**VILLAGE OF DOWNERS GROVE
REPORT FOR THE VILLAGE COUNCIL MEETING
MAY 15, 2012 AGENDA**

SUBJECT:	TYPE:	SUBMITTED BY:
Annexation with Rezoning to B-2, Lot Consolidation and Special Use for a drive-through use	<ul style="list-style-type: none"> ✓ Resolution ✓ Ordinance Motion Discussion Only 	Tom Dabareiner, AICP Community Development Director

A resolution and ordinances have been prepared for annexation, rezoning, lot consolidation and special use for a Walgreens store at the northwest corner of 63rd Street and Woodward Avenue.

To: Plan Commission
From: Jeff O'Brien, AICP, Planning Manager
Subject: PC-39-11, Annexation with Rezoning to B-2, General Retail Business, Final Plat of Subdivision for Lot Consolidation and Special Use for a drive-through use – Northwest corner of 63rd Street and Woodward Avenue
Date: January 9, 2012

SITE PLAN

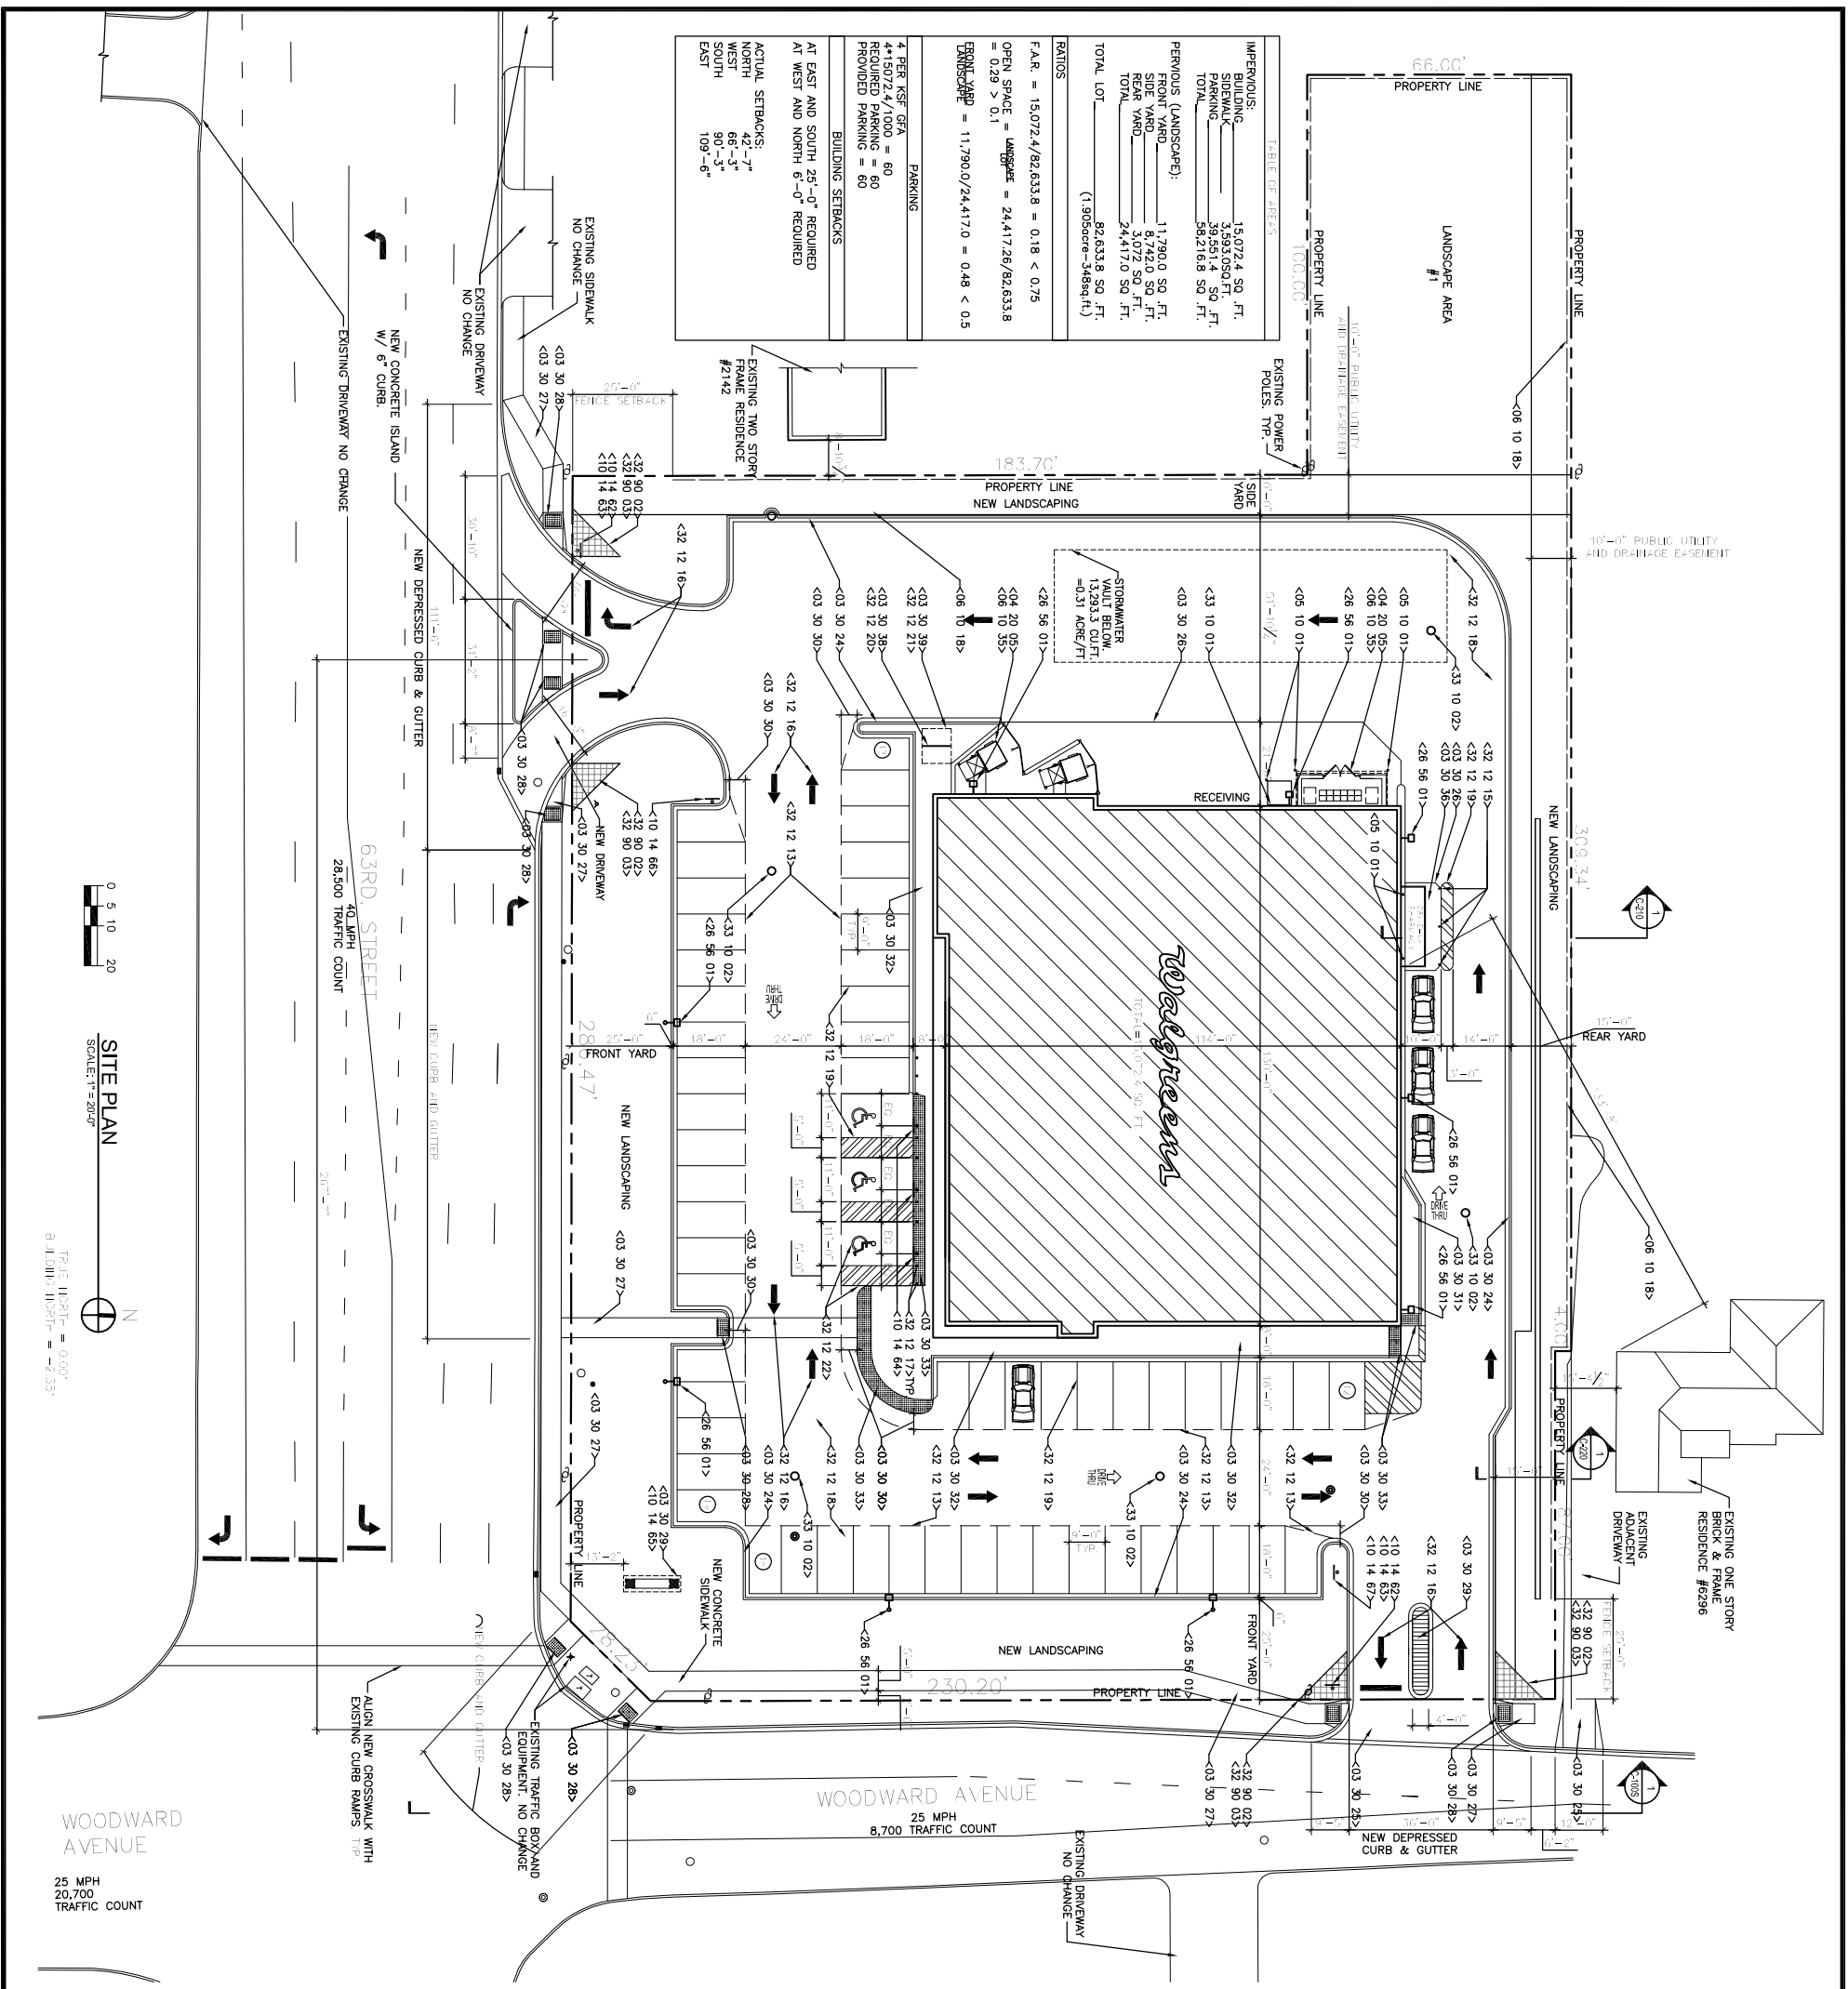
This item was discussed at the February 7, 2012 Village Council meeting. The petitioner has submitted revised plans that show right-in, right-out only on 63rd Street and one lane in, one lane out on Woodward, with a sign prohibiting left turns from the site onto Woodward. The conditions of the attached special use ordinance have been changed to reflect this design. Staff recommends approval on the June 5, 2012 Active Agenda. The revised site plans are attached.

FILE SIGNATURE - Exhibiting		SHEET NUMBER	
DRAWN BY: MC	GHA PROJECT #	1	OF 1 SHEETS
DATE: 1/4/12	2878.941		
CHECKED BY: WCG	SCALE: 1" = 50'		
DATE: 1/4/12

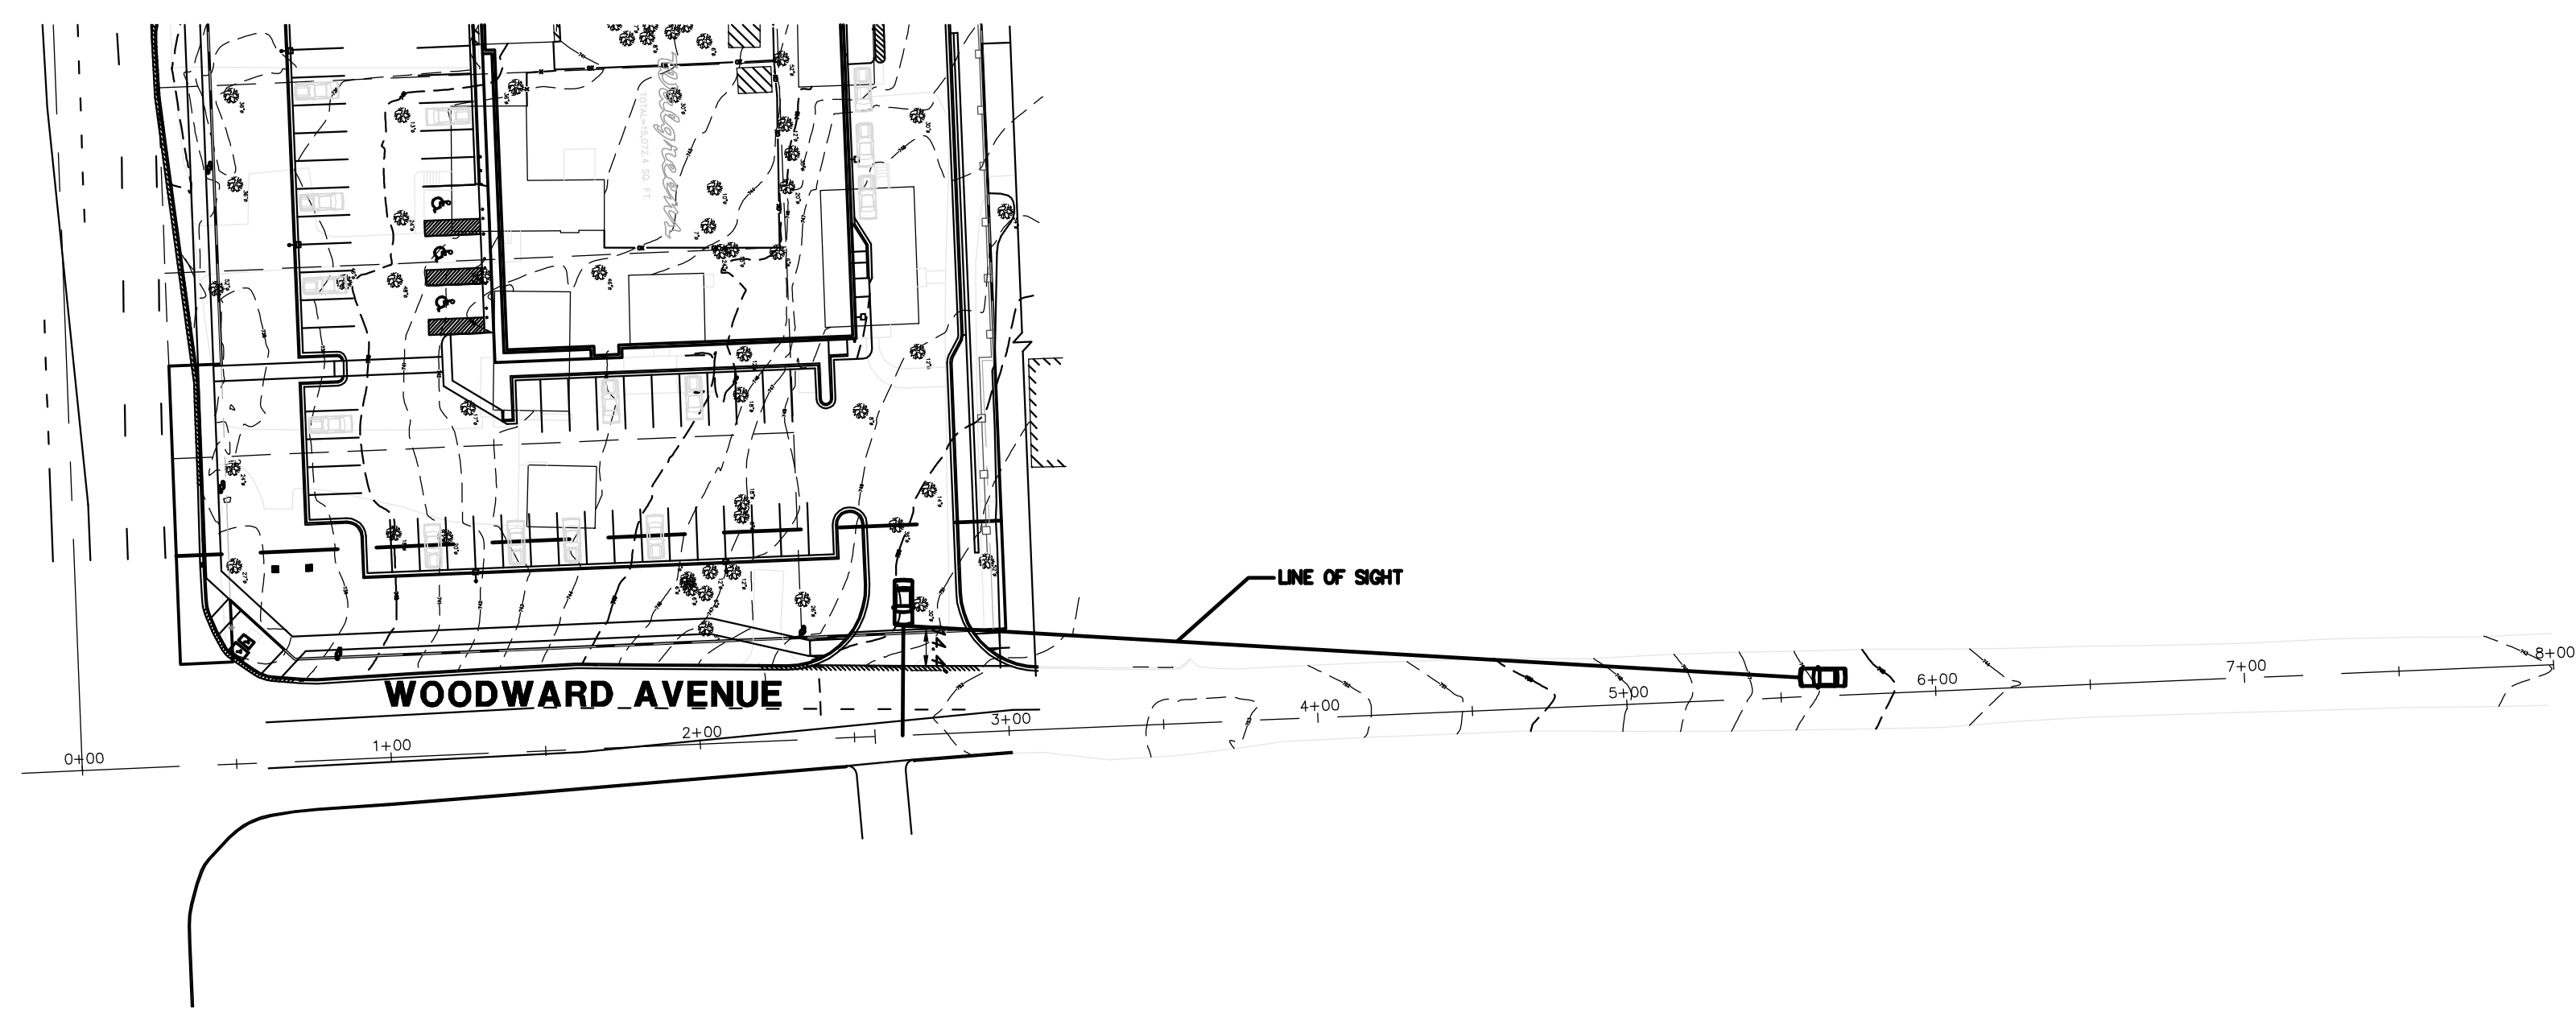
2. Provide a site distance study for the driveway access on Woodward Avenue

POSTED SPEED LIMIT ON WOODWARD AVENUE = 25 mph
 DESIGN SPEED ON WOODWARD AVENUE = 30 mph
 SLOPE OF WOODWARD AVENUE = 4.8%
 REQUIRED STOPPING SIGHT DISTANCE = 190 feet
 ACTUAL STOPPING SIGHT DISTANCE = 290 feet
